**NOTIFICATION NO. 1600-2015-0100-R1 – PROJECT INSPECTION REPORT**

This Project Inspection Report is being submitted at the request of David Manthorne to facilitate the processing of an Amendment proposing a change in Applicant/landowner. Chris Carroll inspected the site on July 16, 2019 and was accompanied by the new landowner, Marko Teovski - Ten Redwoods LLC.

Subject: Engineering-Geologic Review; Existing Agricultural Pond, AP #208-241-017  
Timberline Ranch Estates, Unit P-134, County Line Rd., Mad River, California

Outlet of Rock Ford – Crossing #1. Note pulverized rock and dust, which shall be addressed by adding more surface rock to the approaches. Photo date: 7-16-2019

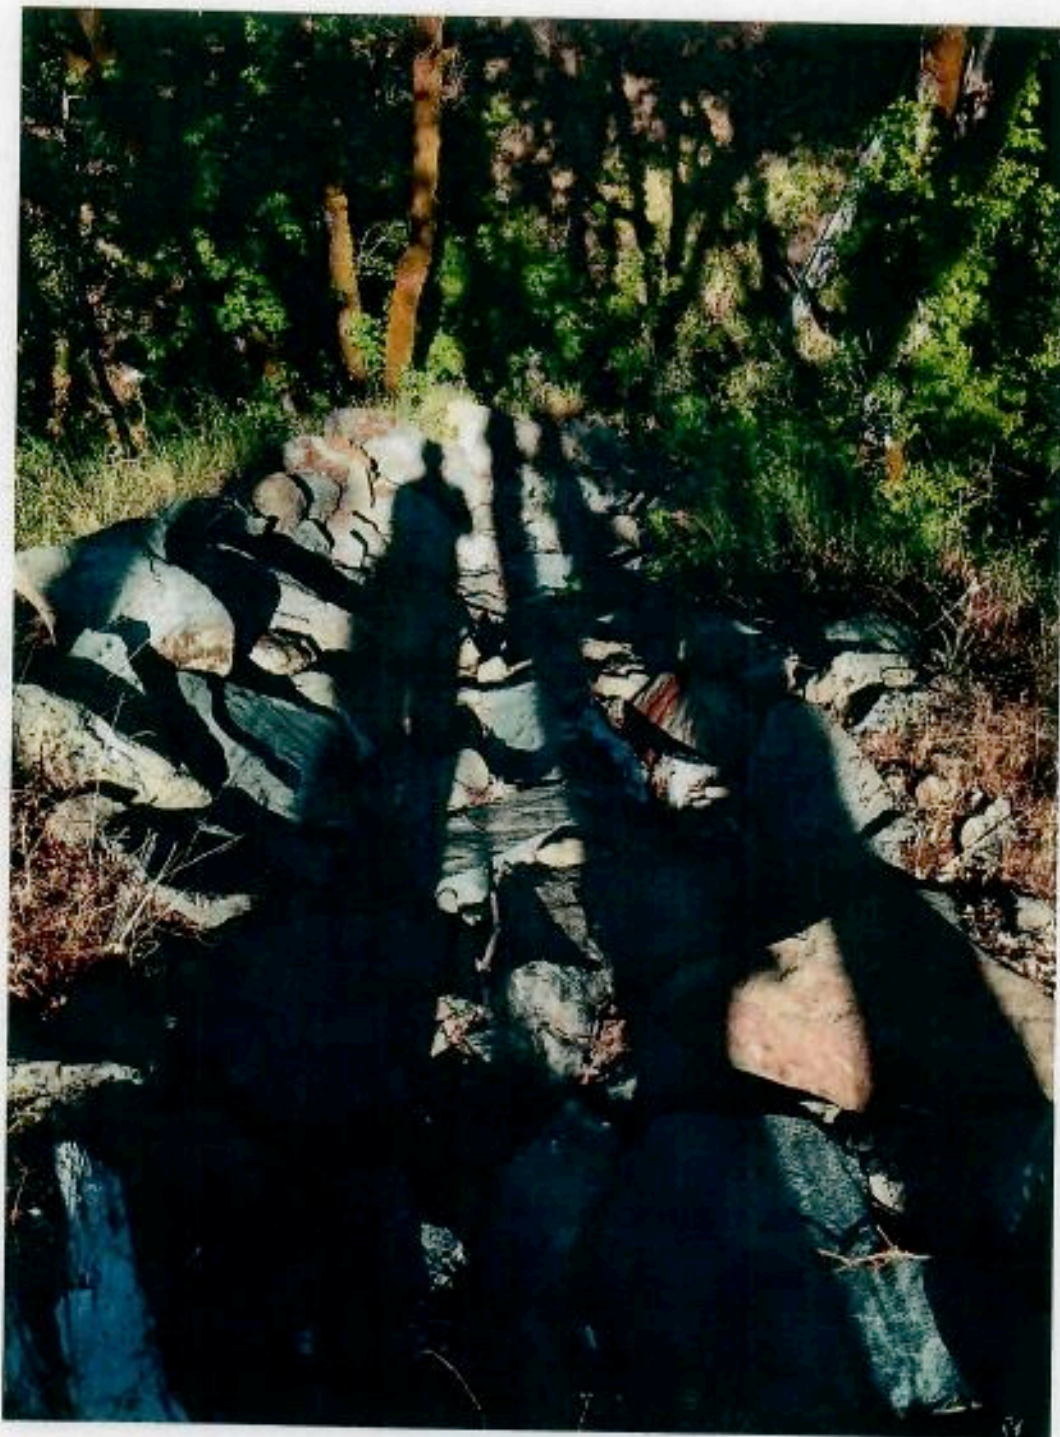
**Crossing #1:** The rocked ford was installed by the former landowner/Applicant per the specifications stated in the notification and agreement. See attached photographs. TRC recommends maintenance in the form of rocking the approaches to provide a stable operating surface. TRC will be preparing the Site Management Plan and this shall be a recommendation.

Rock-lined V-ditch-Pond Spillway. Photo date: 7-16-2019

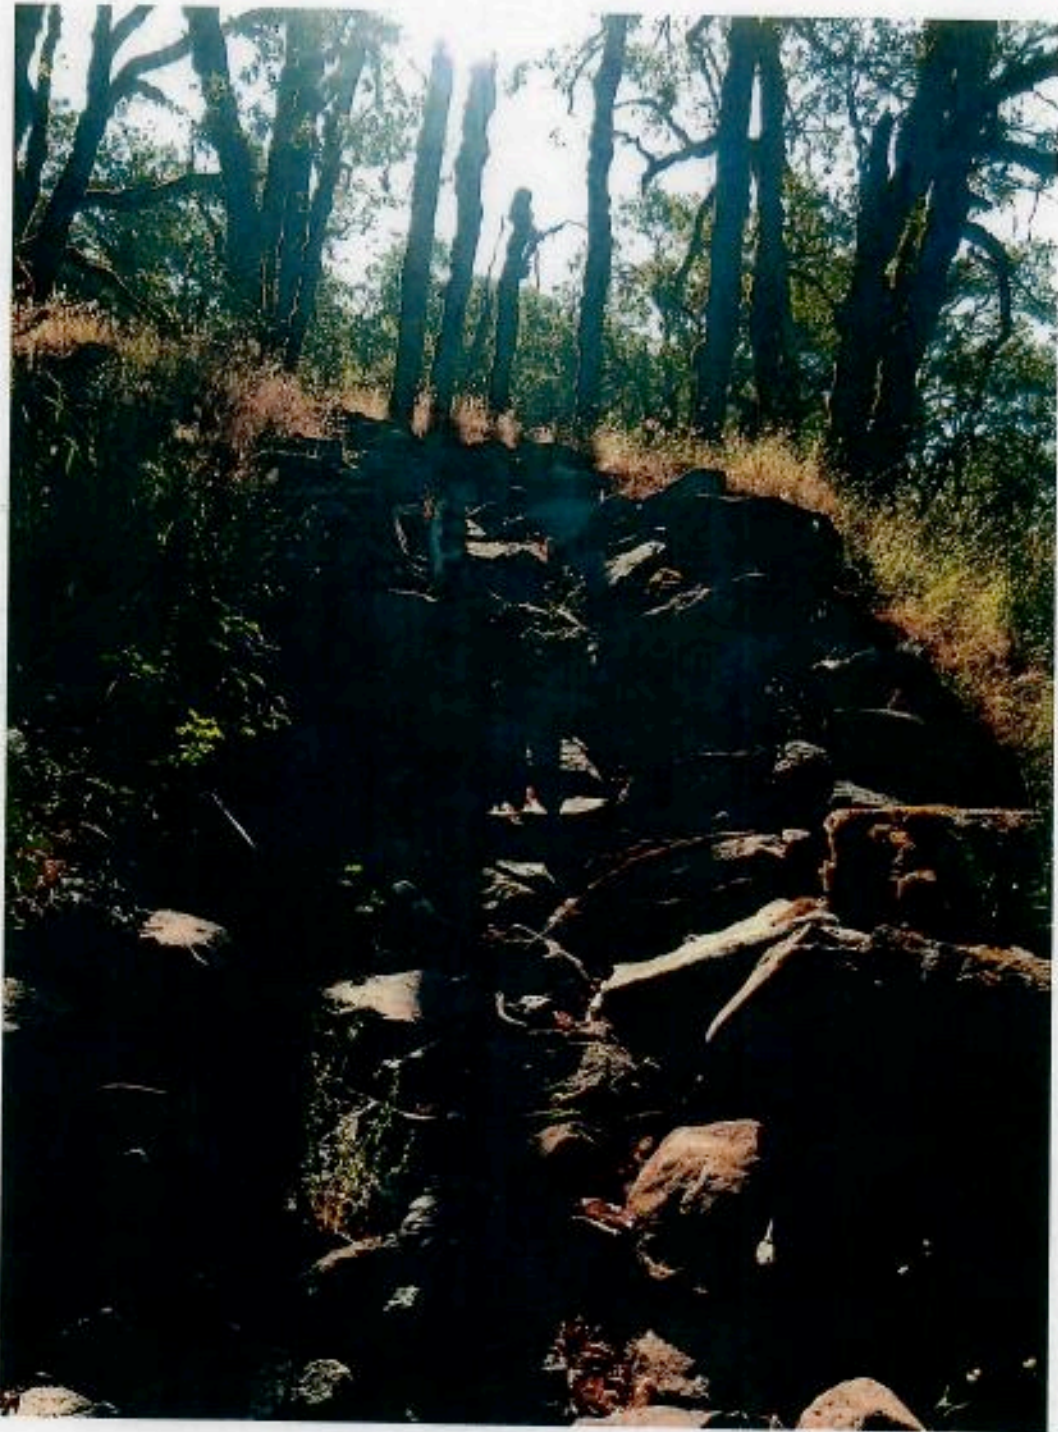
**Pond Inspection:** See attached Engineering-Geologic Review. All of the CEG's recommendations have been implemented by the former landowner/Applicant as follows: (1) Freeboard was increased to 2-feet; (2) Pond spillway was reconstructed with 1/8-1/16-ton boulders over geotextile; (3) Pond lined with Bentonite, and (4) Erosion control was applied post reconstruction. See attached photographs.
